FALCON ACRES
14655 DAVIS ROAD

DESIGNED BY JF
DRAWN BY JF
CHECKED BY LD
H-SCALE AS NOTED
V-SCALE AS NOTED
JOB NO. 2142.00
DATE ISSUED 11/26/21
SHEET NO. 6 OF 10

FALCON ACRES
14655 DAVIS ROAD
GRADING & EROSION CONTROL PLAN
DETAILS SHEET

GRADING & EROSION CONTROL LEGEND:

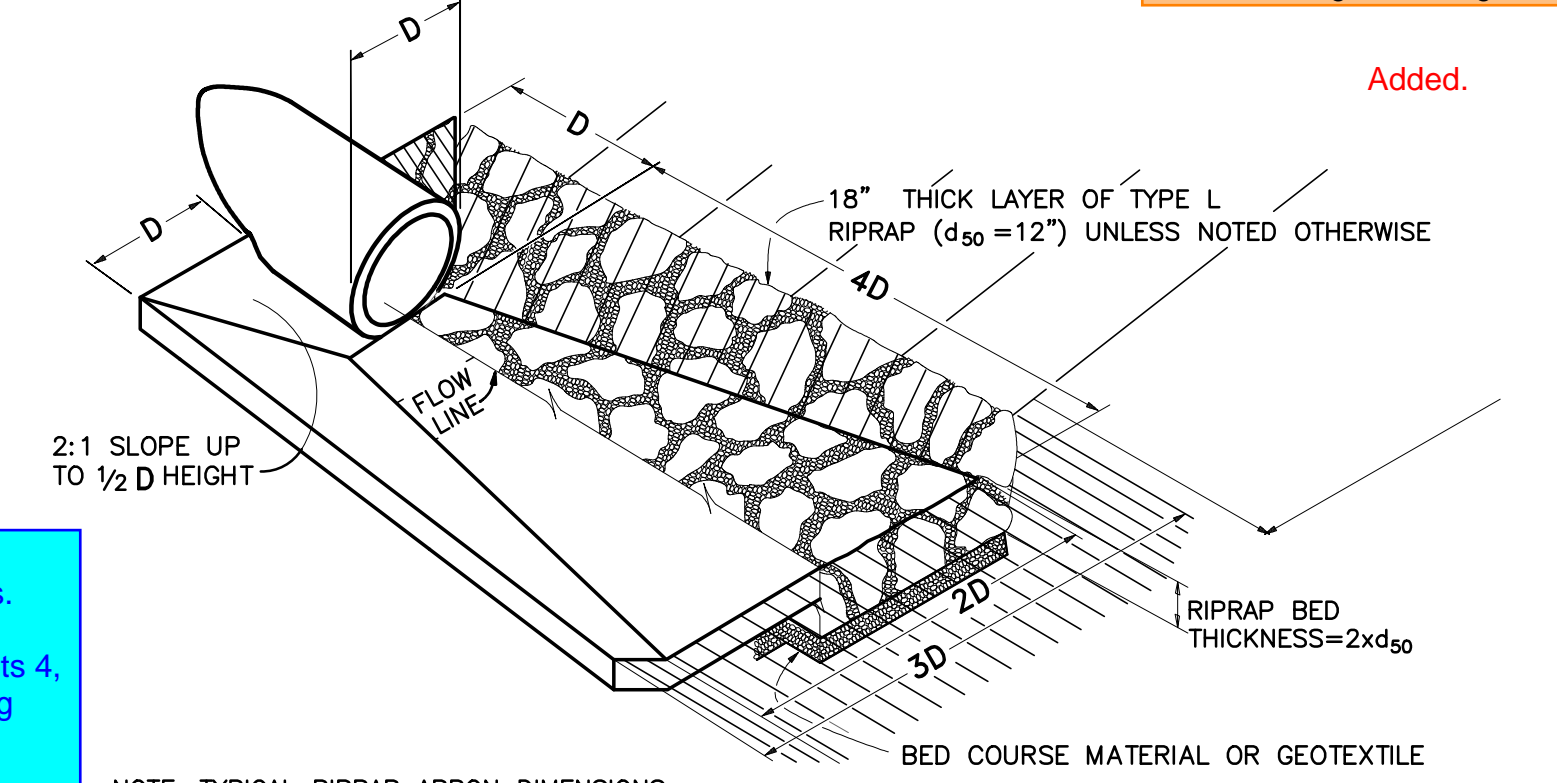
- SF SILT FENCE (SF) INITIAL & INTERIM
- SBB STRAW BALES (SBB) INITIAL & INTERIM
- RR RIPRAP FINAL add bubble for "RR" as shown on plans.
- 6490 EXISTING CONTOURS

- PROPOSED EASEMENT
- EXISTING GRAVEL EDGE
- EXISTING FENCE
- EXISTING BOUNDARY LINES
- EXISTING BERM
- LIMITS OF DISTURBANCE Items H and M. If "limits of disturbance" and "construction boundary" are the same, change to "limits of construction/disturbance" or otherwise show as separate line types for each on the legend and figure.

- 6490 PROPOSED CONTOURS Added.
- X 99.00 PROPOSED SPOT ELEVATION (FLOWLINE)
- IP INLET PROTECTION (STRAW BALES) (IP) INITIAL & INTERIM
- SSA STABILIZED STAGING AREA (SSA) INTERIM

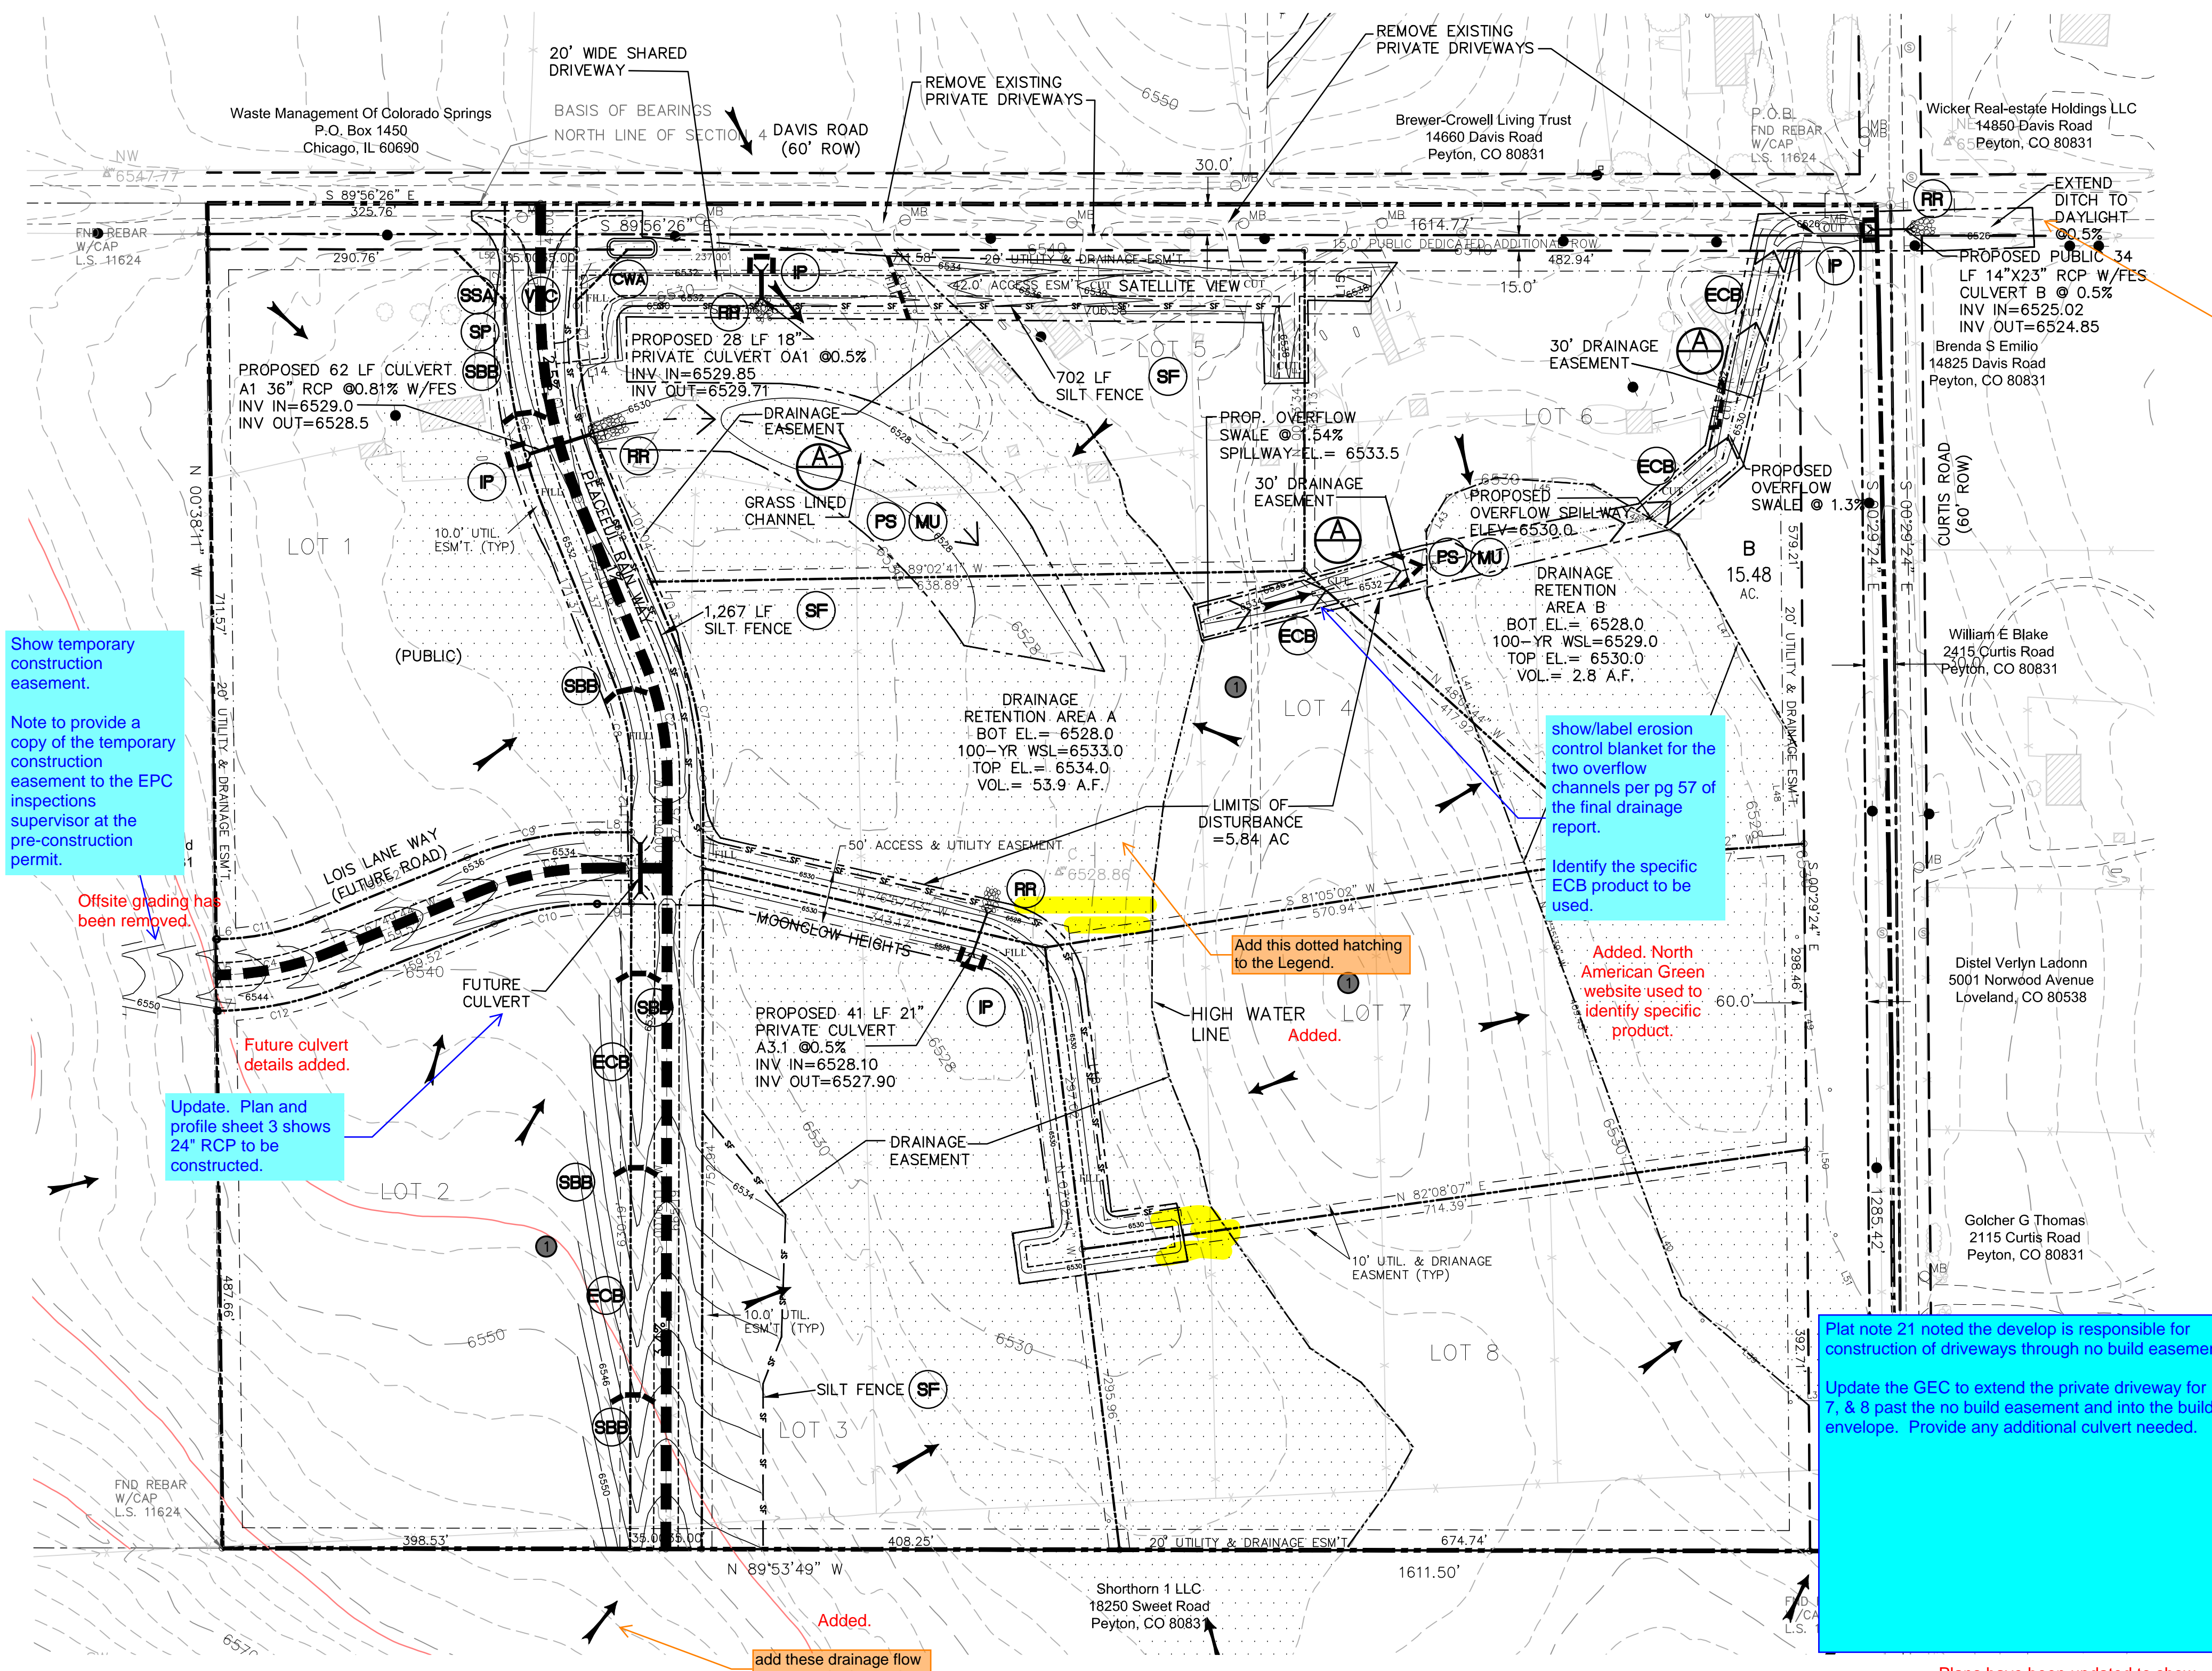
Show temporary construction easement.
Note to provide a copy of the temporary construction easement to the EPC inspections supervisor at the pre-construction permit.

Update. Plan and profile sheet 3 shows 24\"/>

Plat note 21 noted the develop is responsible for construction of driveways through no build easements.
Update the GEC to extend the private driveway for Lots 4, 7, & 8 past the no build easement and into the building envelope. Provide any additional culvert needed.

Checklist item "I" - add a note about condition and type of existing vegetation.

Offsite grading has been removed.

Future culvert details added.

Plans have been updated to show possible driveway locations & grading for Lots 4, 7 & 8 past the no-build easement. Culvert added to Lot 4.
